**MONTGOMERY COUNTY HISTORIC PRESERVATION COMMISSION**  
**STAFF REPORT**

<b>Address:</b>	8000 Overhill Rd., Bethesda	<b>Meeting Date:</b>	10/23/2019
<b>Resource:</b>	Contributing Resource <b>Greenwich Forest Historic District</b>	<b>Report Date:</b>	10/16/2019
<b>Applicant:</b>	Amil Gupta Mark Kramer, Architect	<b>Public Notice:</b>	10/9/2019
<b>Review:</b>	HAWP	<b>Tax Credit:</b>	n/a
<b>Case Number:</b>	35/165-19-D	<b>Staff:</b>	Dan Bruechert
<b>PROPOSAL:</b> Porch Enclosure

## SINGLE FAMILY DETACHED HOME - EXISTING PORCH ENCLOSURE

2 EXTERIOR ELEVATION (LOOKING EAST)  
SCALE: 3/8"=1'-0"

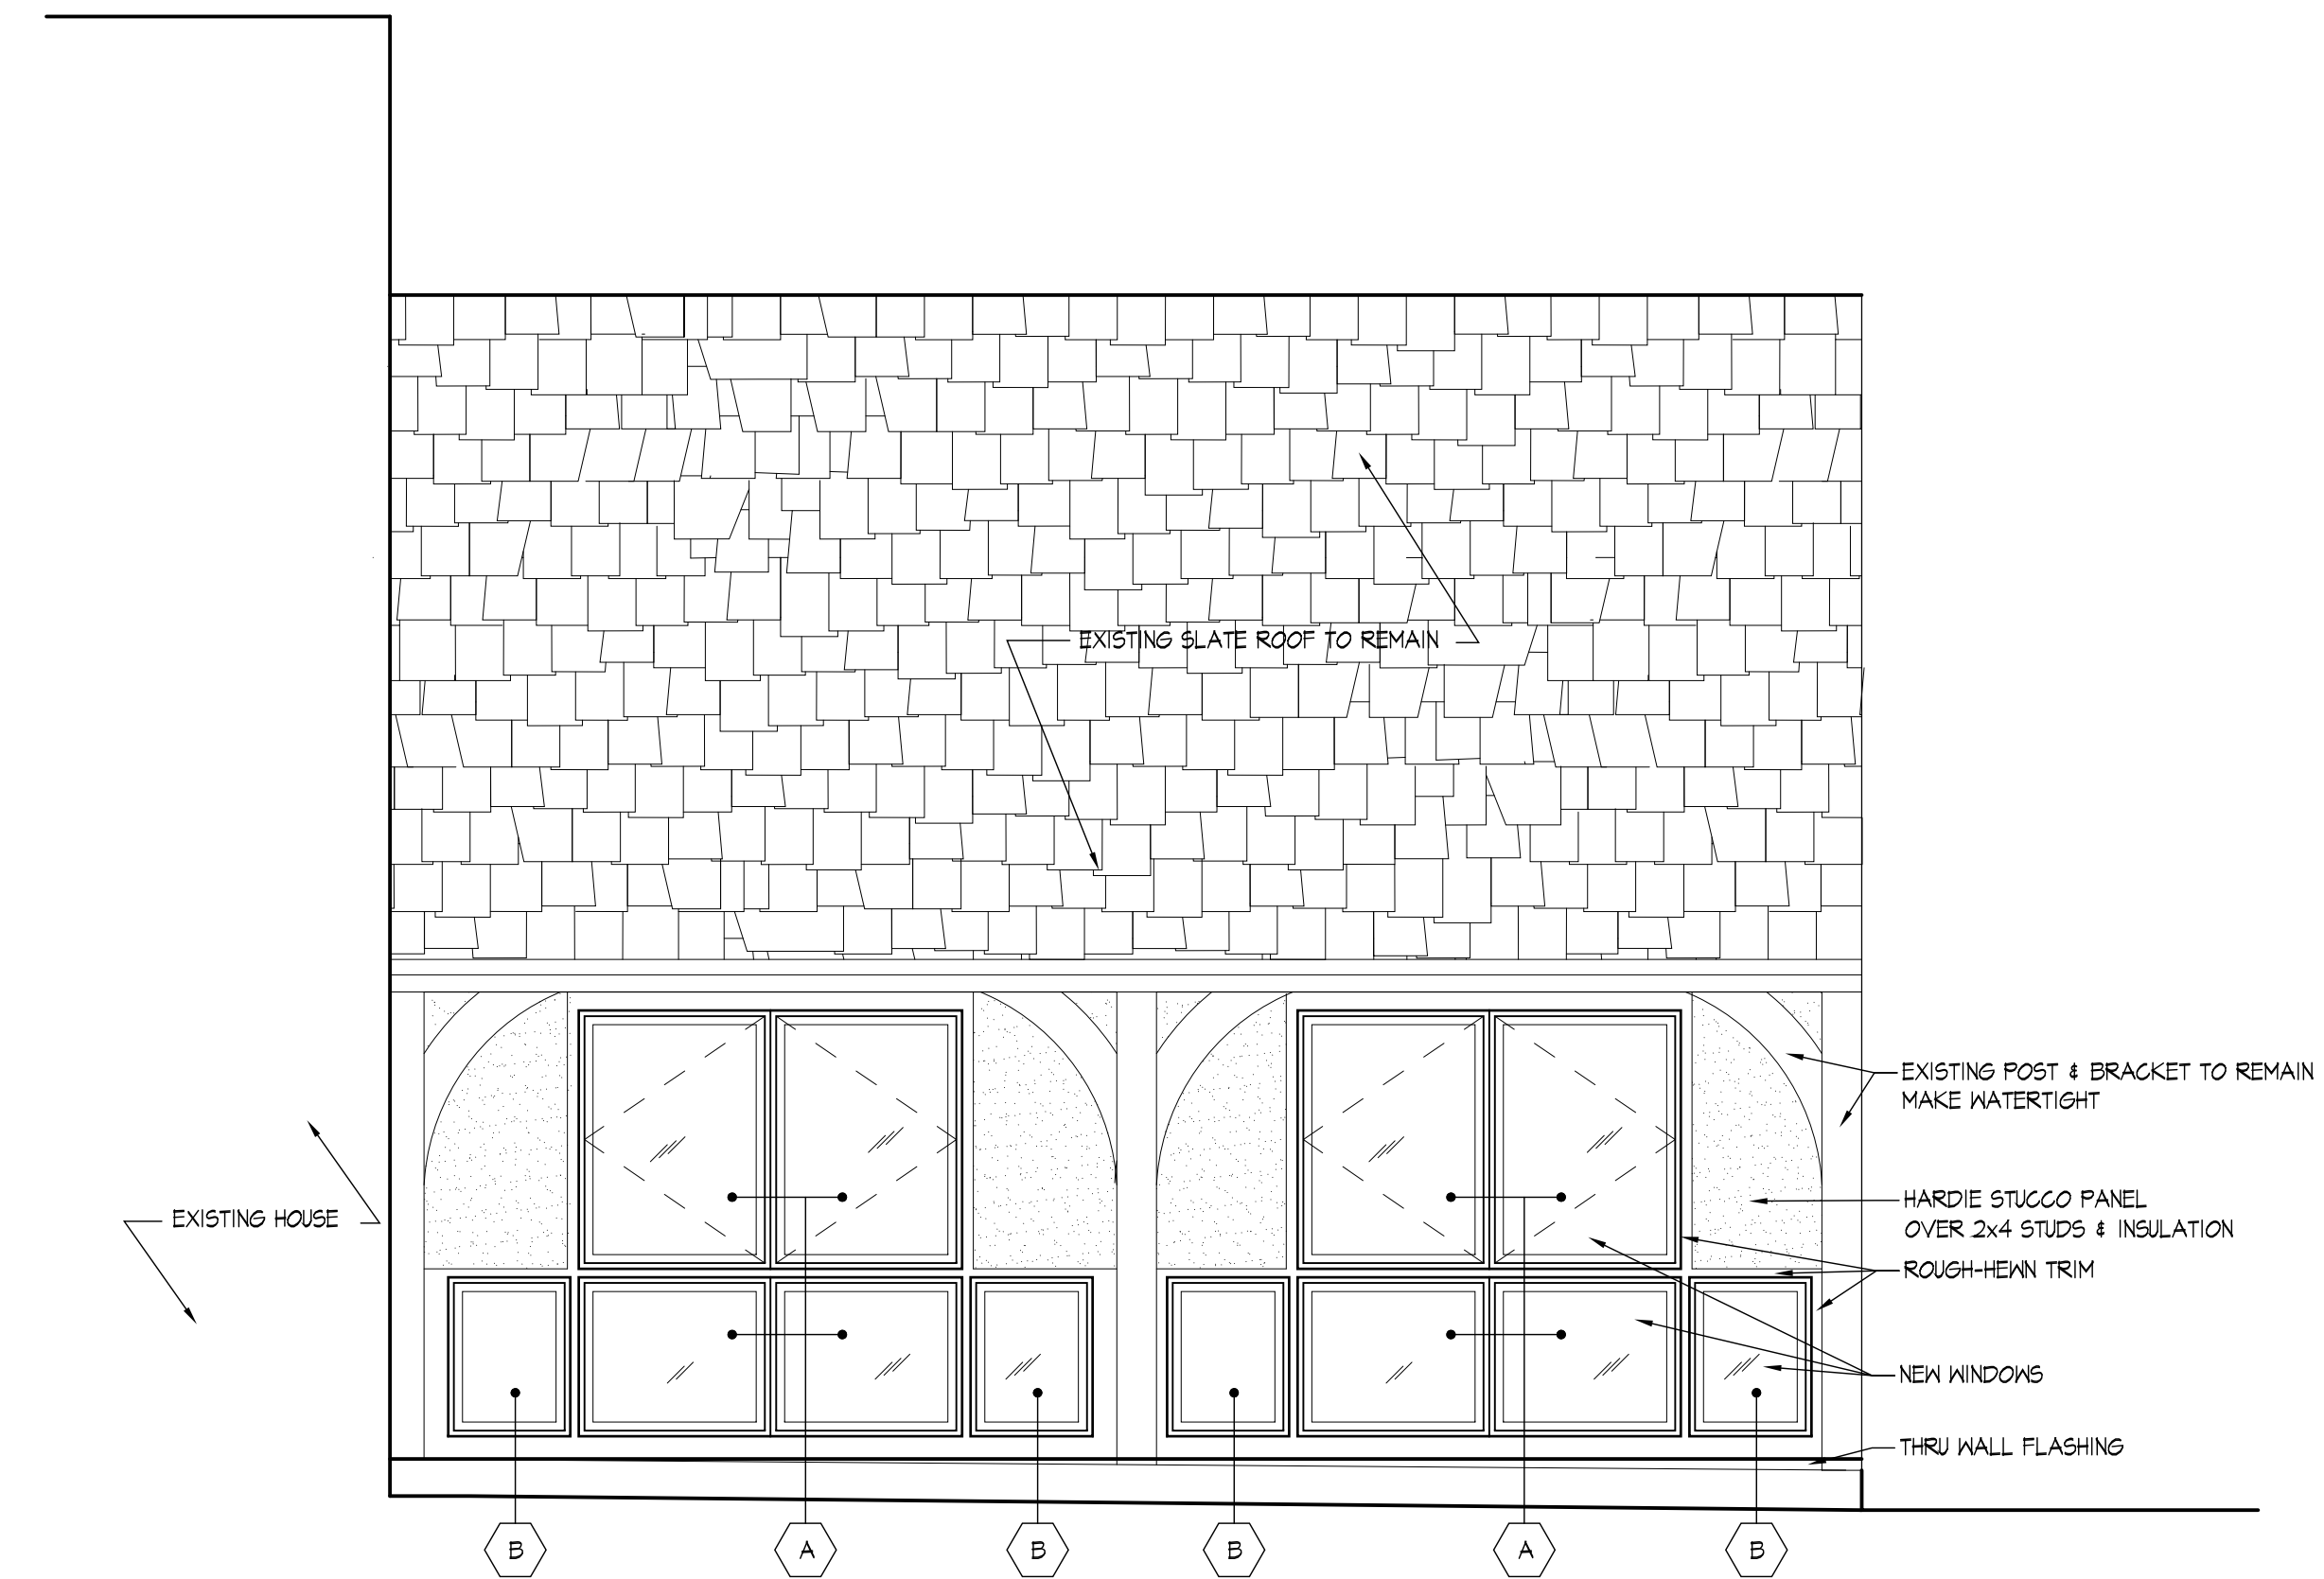
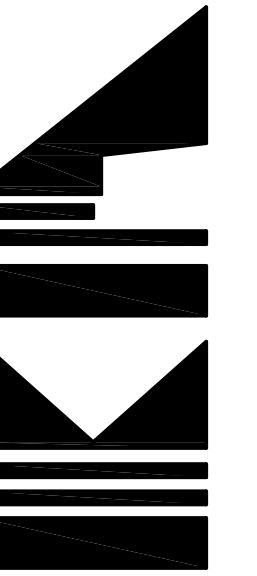
The applicant proposes to enclose the existing porch with a combination of Marvin windows, matching

the frame details of the approved replacement windows,<sup>2</sup> and stucco fiber cement panels. The proposed window configuration consists of four low, fixed windows with two larger casement windows above in each of the two bays on the north and south elevation. The east elevation will have a pair of French doors, flanked by fixed sidelites and fiber cement stucco panels. The fiber cement panels will be inset so that they are behind the existing post and brackets, leaving the original structure exposed. Additional structural elements will be constructed on the interior of the porch. While there is no stucco on the porch in its current configuration, this treatment is present on limited areas elsewhere on the house. Stucco is a material commonly applied to Tudor Revival style architecture, and its inclusion on the side porch will not introduce a new material to the building or the District (see Fig. 2, below).

alteration that the *Design Guidelines* envisioned would be approvable under many circumstances with the appropriate application of design review. In short, should the HPC allow the applicant to enclose the porch and remove the existing, historic, post and brackets; or should the HPC allow for the enclosure of the porch with some fiber cement panels and retain all of the existing historic post and brackets?

In determining the preferred outcome for a porch enclosure, the Greenwich Forest *Design Guidelines* (D10) don't provide explicit guidance, aside from stating that the HPC is responsible for ensuring that the enclosed porch is "compatibly designed" and that the significant architectural features are preserved. The *Standards* (particularly 2 and 5) offer a bit more guidance by stating that the historic character of the house should be retained and that distinctive materials, construction techniques, and/or examples of craftsmanship that characterize a property will be preserved. Staff's finding that post and brackets are distinctive, character defining features, and this interpretation of the *Standards* strongly encourages their retention in any alteration. Staff finds that under the current proposal the character defining post and brackets will remain visible from the public right-of-way.<sup>3</sup>

Staff further finds that there are only two ways that would allow for the enclosure of the porch while retaining these elements. First, the applicant could install large windows behind the post and brackets. This would retain most of the existing, open appearance with only the addition of the window division. Staff, in fact, recommended this as a potential design solution. The architect responded under this proposal there would not be sufficient bracing to satisfy the window load requirements and it was infeasible. The second method of enclosing the porch is the one presented in the application. The current proposal will retain the historic, character defining features and introduce sufficient structural members to ensure the porch's retention as an integral part of the historic building.

Furthermore, we have left the exposed timber construction on the exterior and are using stucco to fill in the spaces which will be left over after the windows have been installed.
